Re: **Initial Submission Review – Porteos** (Infrastructure CSP)
Application Number: **DA-1903-13**
Case Number(s): **2019-6032-00**

INFRASTRUCTURE CONTEXTUAL SITE PLAN NO.5 AT PORTEOS

INFRASTRUCTURE SITE PLAN
E. 64TH AVENUE PLAN VIEW

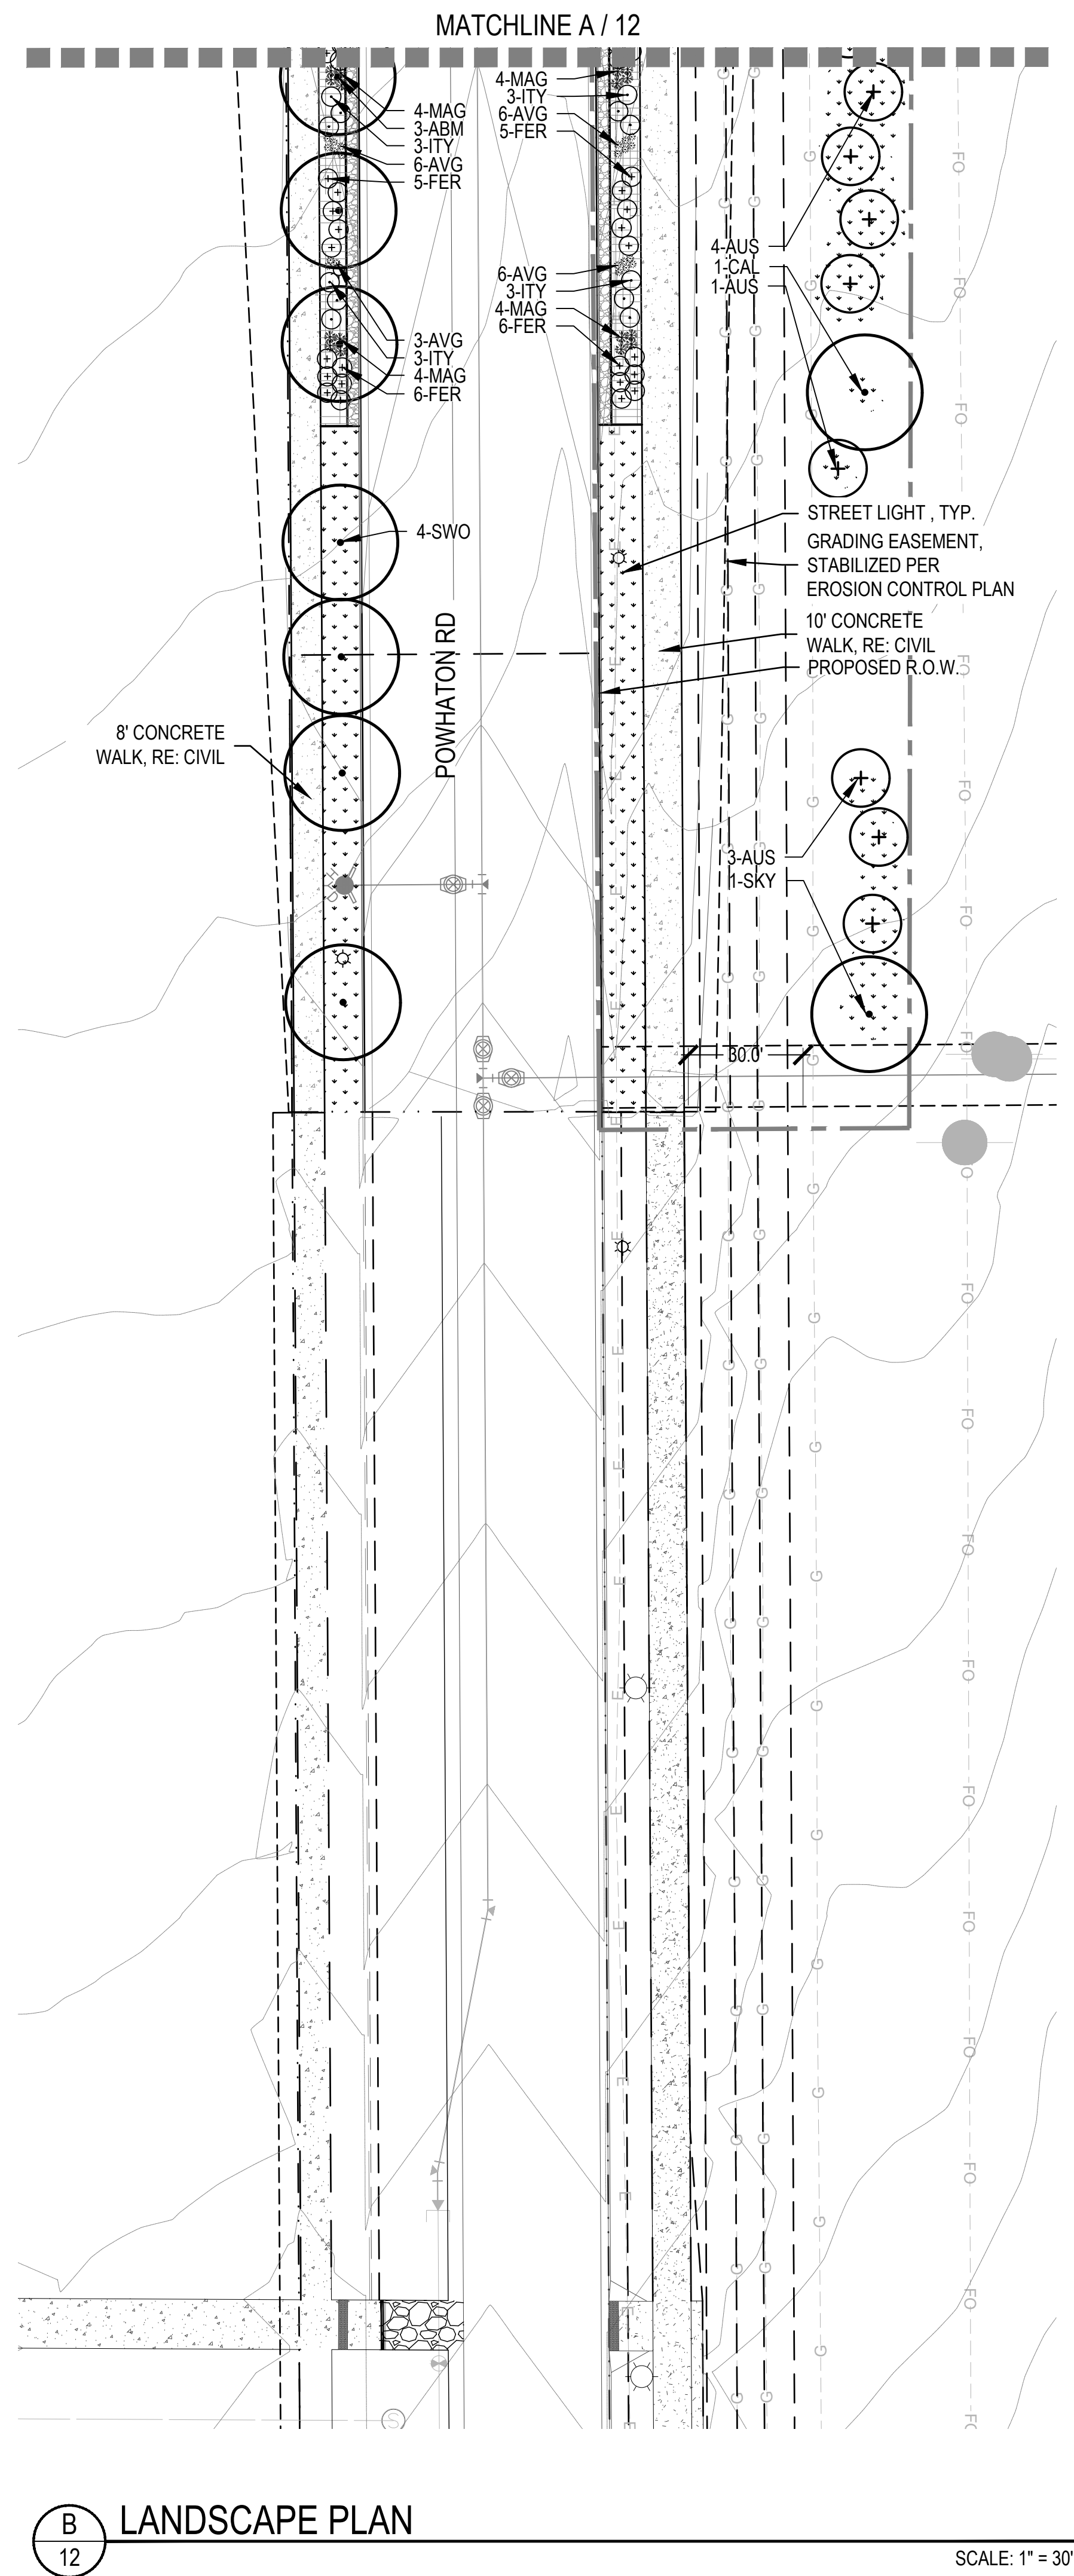
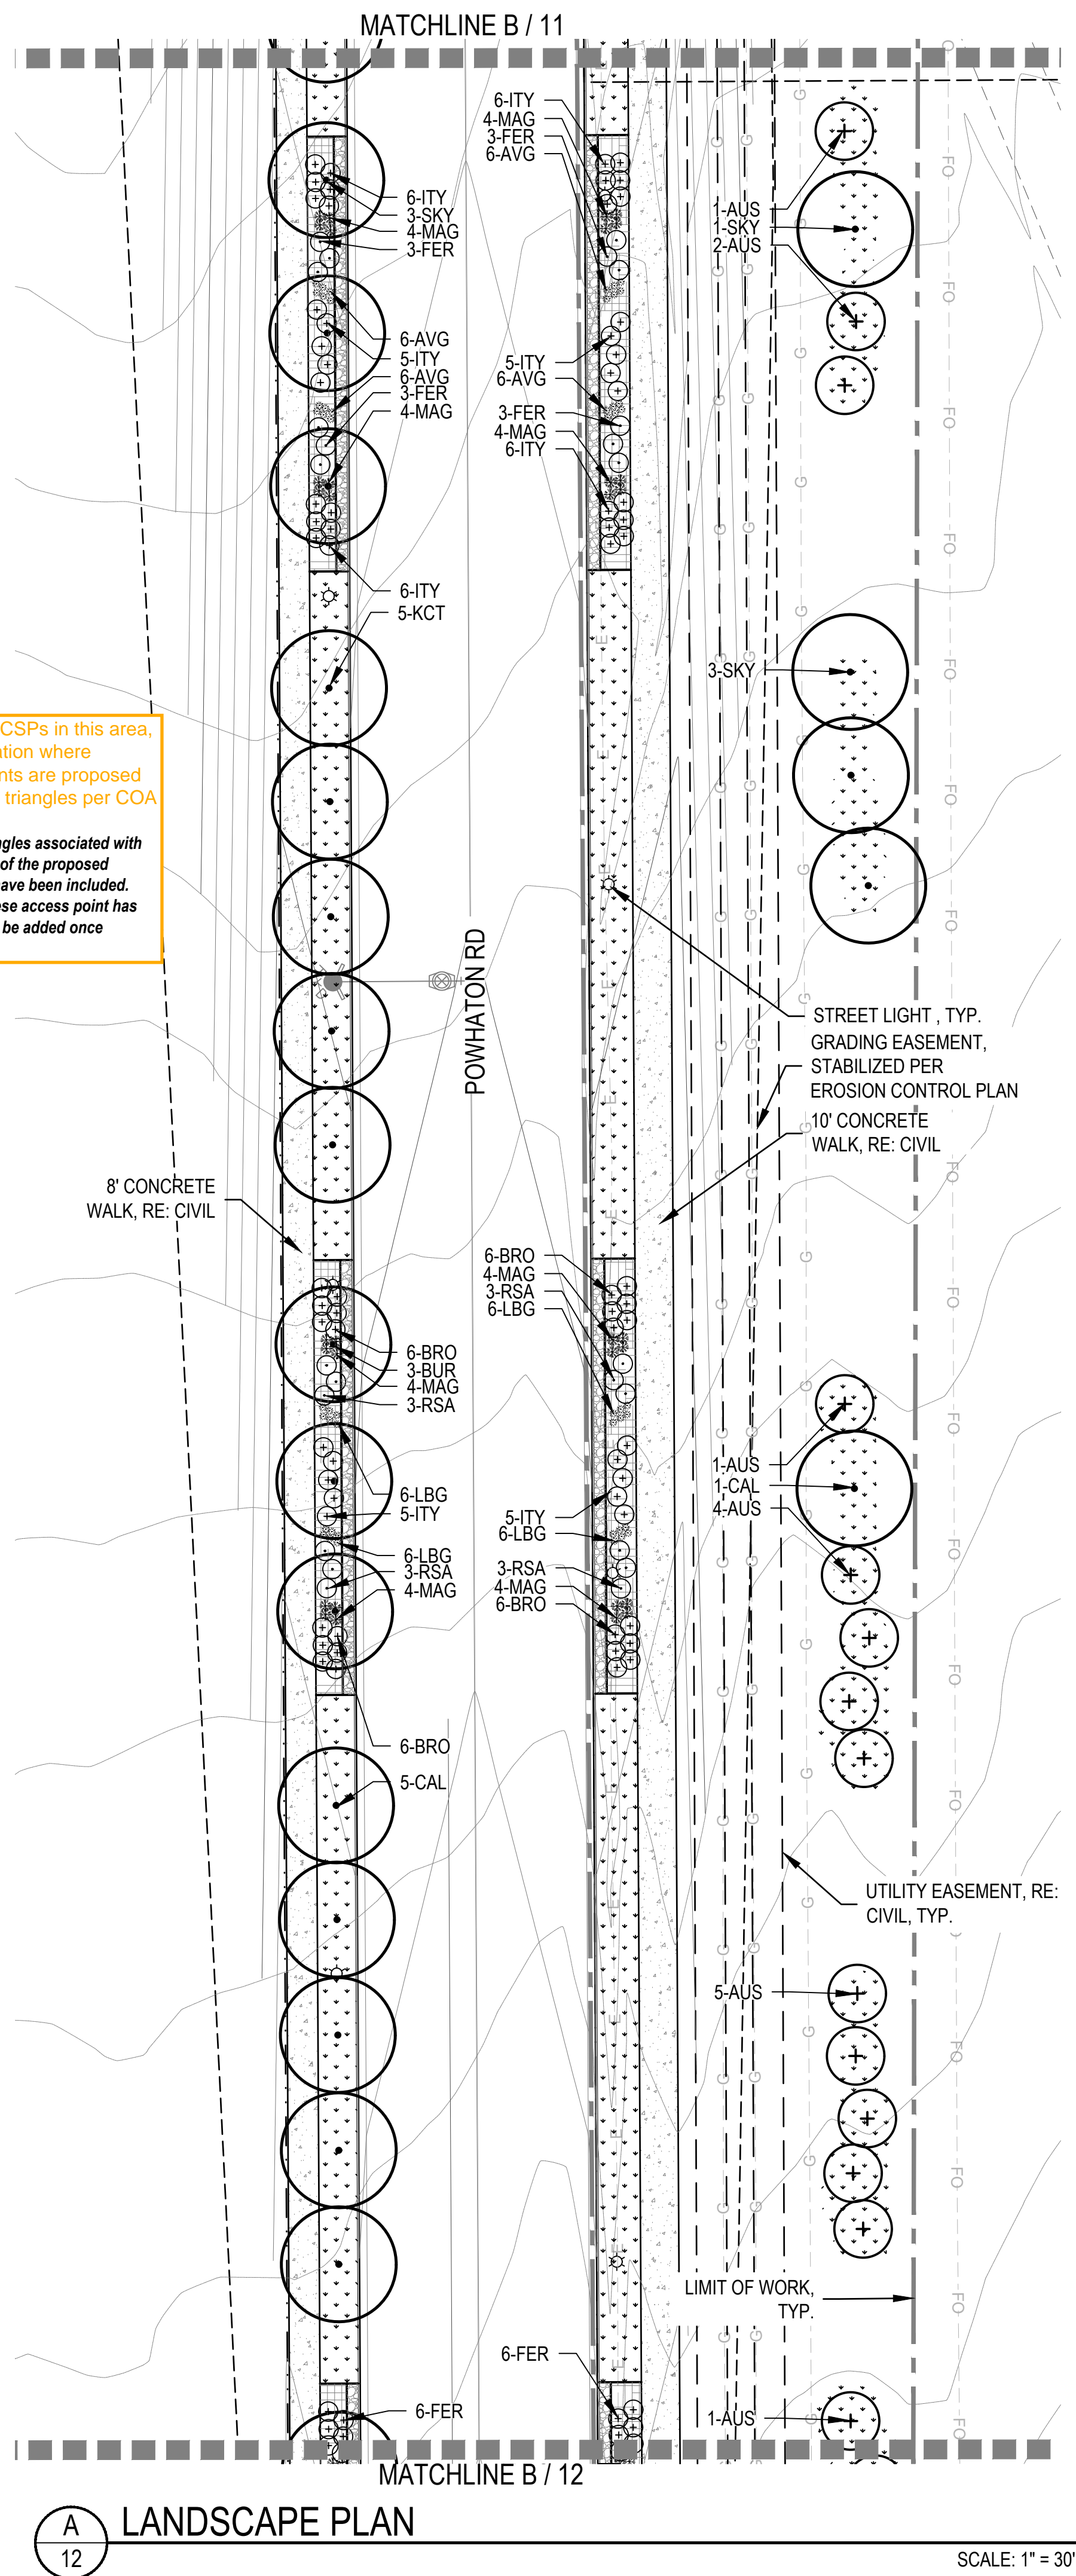
Location of all of these landscaping will change once the NEATS required laneage is included.
Response: Landscape has been updated per NEATS laneage.
